DEVELOPMENT REVIEW BOARD REPORT

CASE NUMBER/ PROJECT NAME	63-DR-2004 Steven Paul Salon		
LOCATION	7045 E 3rd Avenue		
REQUEST	Request approval of minor modification to elevations for an existing commercial building, including a new vestibule addition, a new trellis system, and a new patio area.		
OWNER	Steven Paul Scholz 480-603-1000	ENGINEER	N/A
ARCHITECT/ DESIGNER	Archicon, LC 602-222-4266	APPLICANT/ COORDINATOR	Paul Sarantes Archicon, LC 602-222-4266
BACKGROUND	<p>Zoning.</p> <p>The property is zoned Downtown Retail Specialty Type One District, Downtown Overlay (D/RS-1, DO). This district permits a salon.</p> <p>Context.</p> <p>The project is located in the central section of Downtown along the Marshall Way, which consists of galleries and retail uses. The parcel is located at the southwest corner of Marshall Way and Third Avenue, specifically 7045 Third Avenue. Currently, the site is occupied by a building in which the applicant operates a salon.</p> <p>Adjacent Uses:</p> <ul style="list-style-type: none">• North: Existing retail building, Downtown Retail Specialty Type One District, Downtown Overlay (D/RS-1, DO).• South: Existing gallery building, Downtown Retail Specialty Ty

7 NORTH ELEVATION

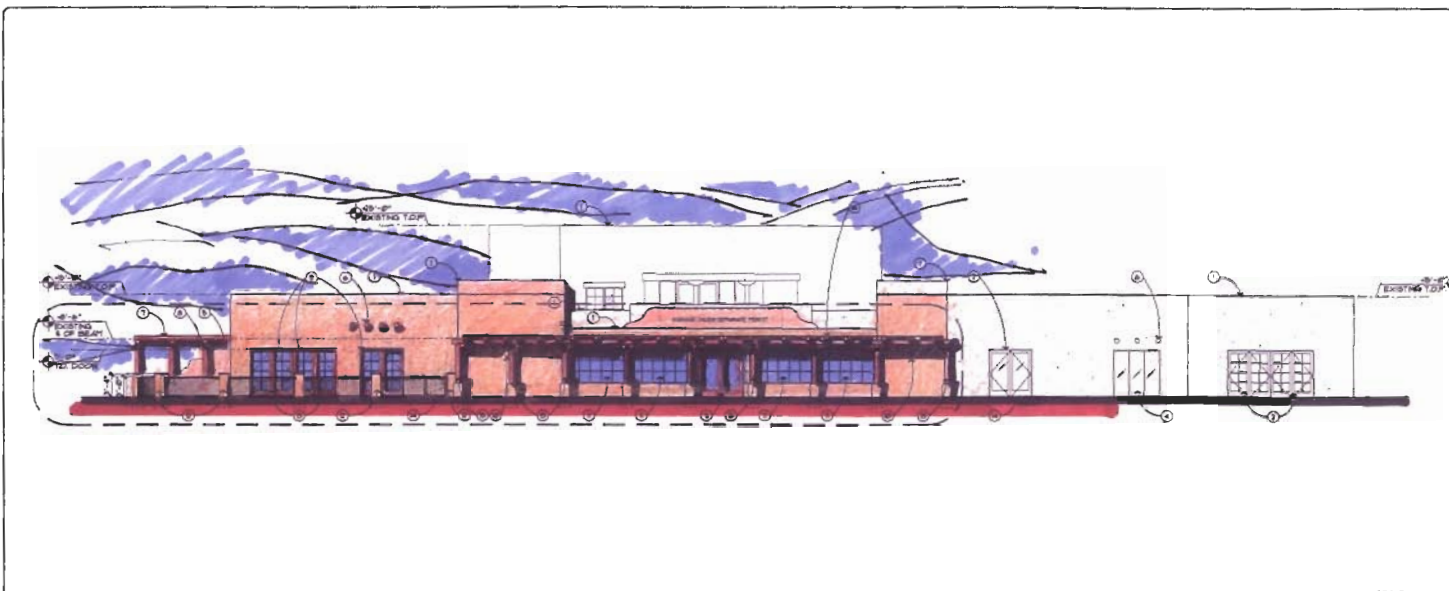
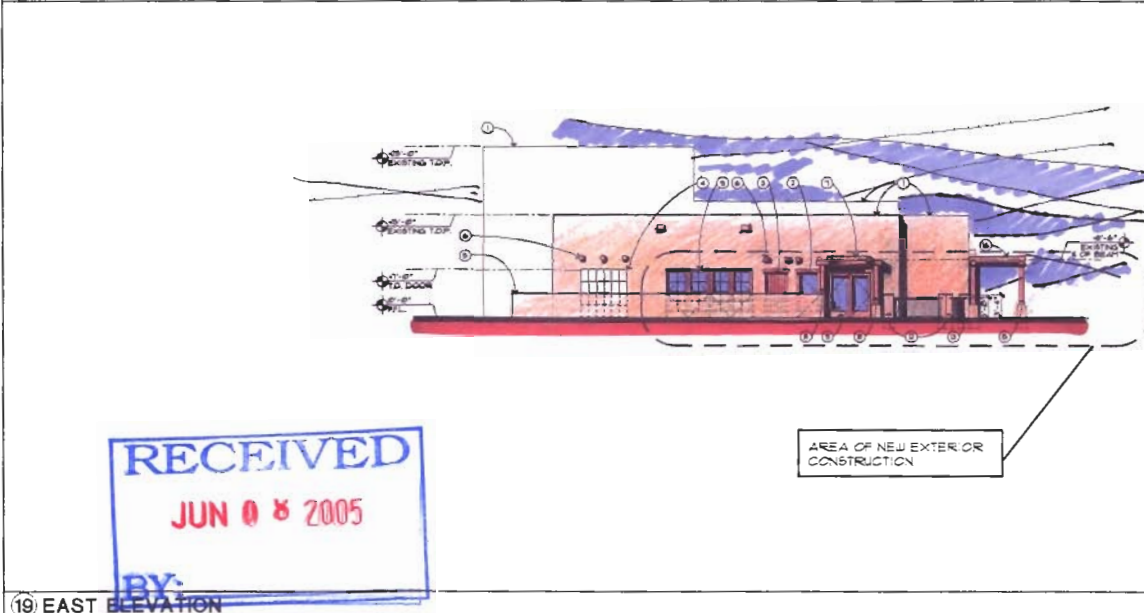
2. Color, materials, and design of new trellis to be consistent with existing trellis located on Marshall Way.
3. All exterior mechanical, utility, and communications equipment shall be screened by parapet or wall that matches the architectural color and finish of the building. Wall or parapet height for roof-mounted units shall meet or exceed the height of the tallest unit. Wall height for ground-mounted units shall be a minimum of 1 foot higher than the tallest unit.

17. For the trellis on the Third Avenue side of the building, the face of the trellis posts shall be at least 2.5 feet from the face of curb. The posts shall be installed in the center of the parking stalls on Third Avenue as reasonably possible. The trellis shall provide a minimum 5 feet – 8 inch wide unobstructed pathway between the posts and the building façade.

6 PATIO RAILING DETAIL

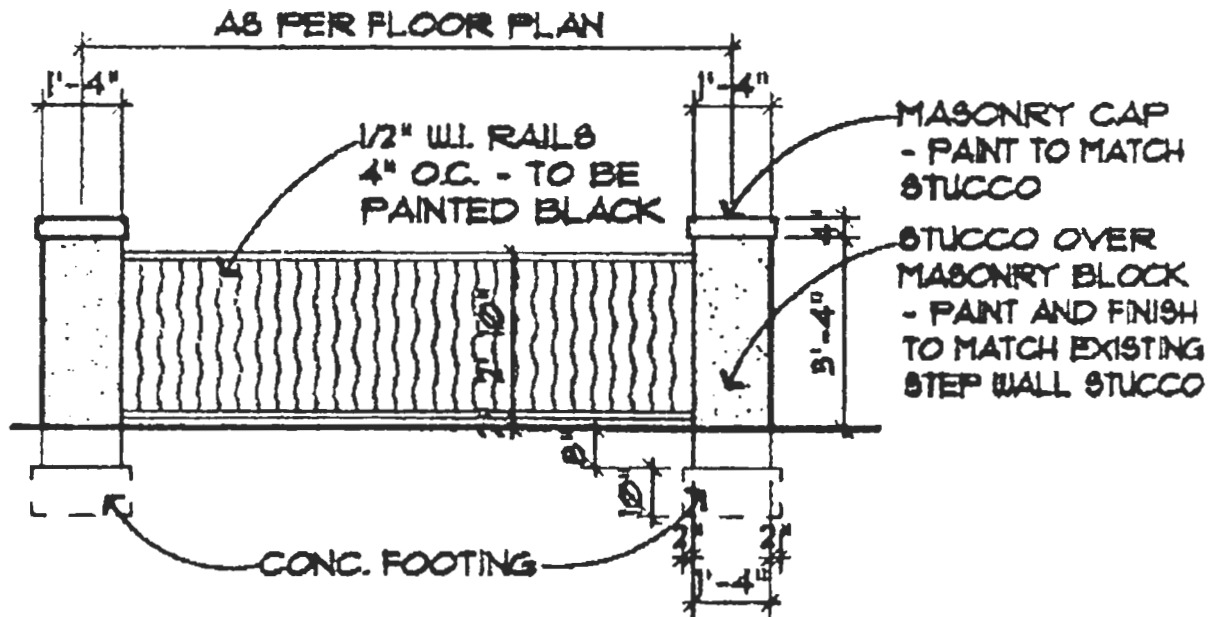
6. Dooley wall fencing shall not be allowed.
7. All walls shall match the architectural color, materials and finish of the building(s).
8. Barrier around proposed patio to be decorative wrought iron with masonry pillars. Wrought iron to be painted black (Dunn Edwards – SP2 Black) and masonry to be painted to match existing main building colors.

9. Wrought iron fence shall not exceed 3 feet in height (pillars shall not exceed 3 inches in height).
10. New front door at vestibule to be recessed so doors do not swing out into sidewalk.
